# **Devon Avenue**

## **Subdivision Application**

Modification-November 10, 2020

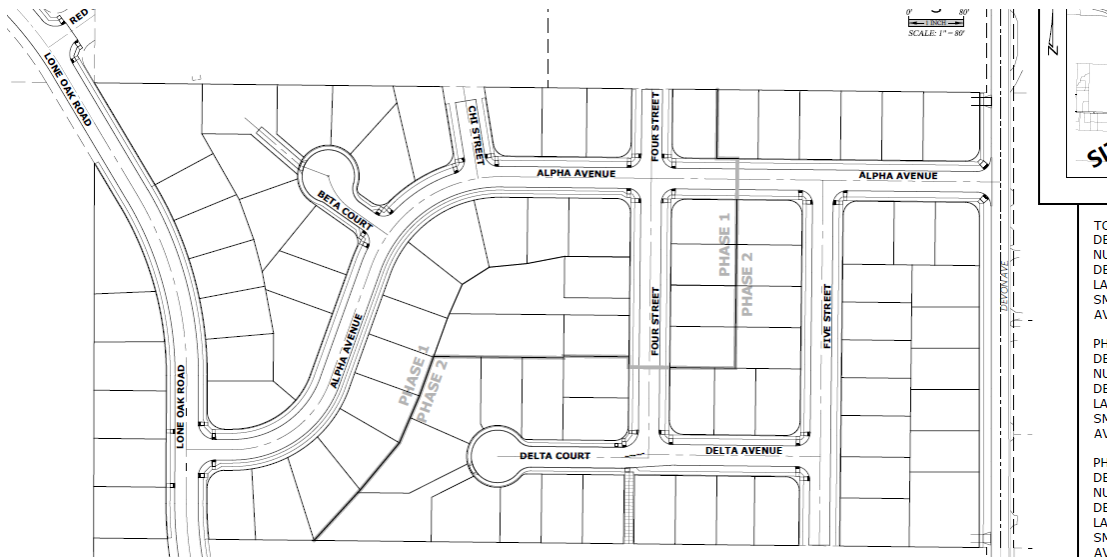
- 1) Alpha Avenue street alignment has changed
- 2) Delta Court street alignment has changed
- 3) Alternative Street Standards to Alpha Avenue to allow a narrow planter strip (4')
- 4)

The street realignments to Alpha Avenue and Delta Court had to be made due to topography of the site. The applicant is requesting Alternative Street Standards to Alpha Avenue to allow a narrow planter strip (4'). The grading that was needed to accommodate those street locations originally approved, created steep slope issues on the site. The realignment of the streets has helped to eliminate steep slope issues in these areas of the proposed subdivision.

## Alternative Proposed Modification:

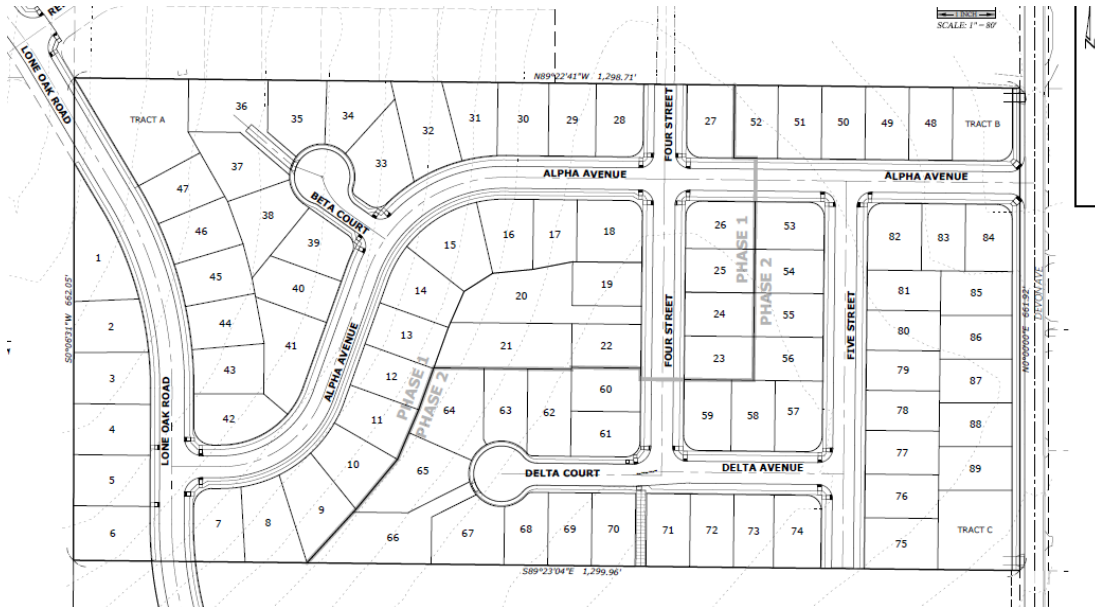
The applicant has also provided an alternative proposal that would allow the elimination of the Chi Street connection to the north. The Chi Street connection will be difficult to construct due to the topography to the north. Furthermore, there are more than adequate street connections provided to the north as shown on the site plan. See sheet AP101.
